Information Only Service Note

N9032B PXA Series Signal Analyzer

A16A3 Reference OCXO Replacement Part Now Available

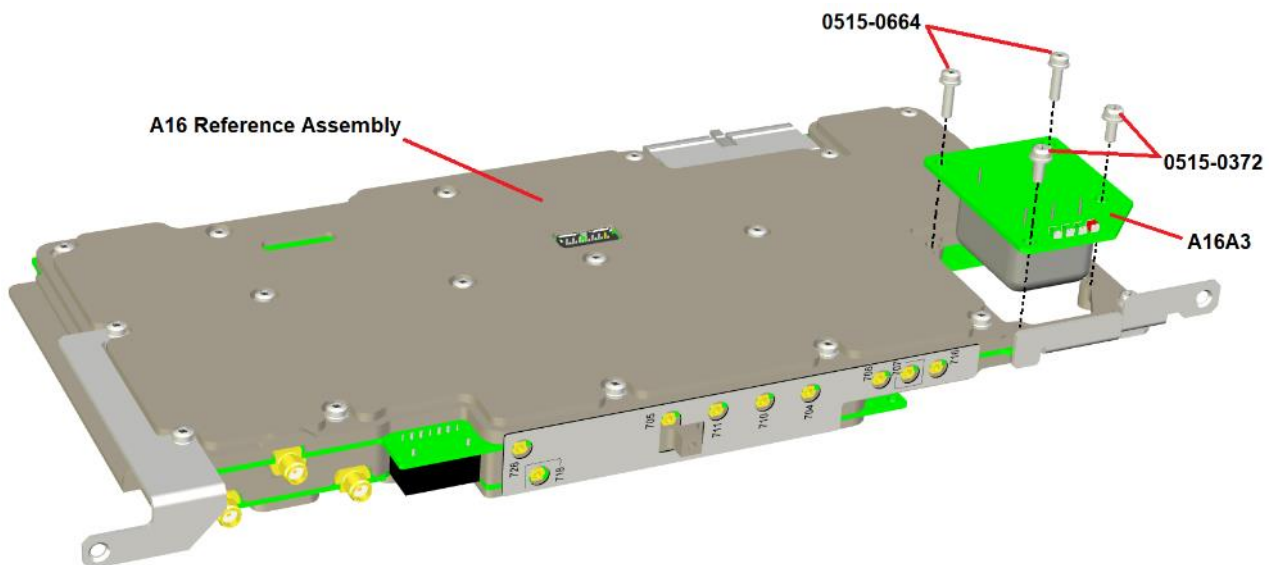
1. Follow the directions in the instrument service guide to remove the A16 Reference assembly from the instrument.
2. Referring to the figure below, remove the four screws shown to remove the A16A3 Reference OXCO from the A16 Reference assembly.

3. Install the replacement A16A3 Reference OXCO onto the A16 Reference assembly, being careful to properly plug the 26-pin interface connector in.
4. Reinstall the four screws, torquing them to 9 in-lbs.
5. Follow the directions in the instrument service guide to replace the A16 Reference assembly into the instrument.
6. Unless stated otherwise in the Post Repair Procedures chapter of the instrument service guide, perform all the tasks specified for the A16 Reference assembly replacement.
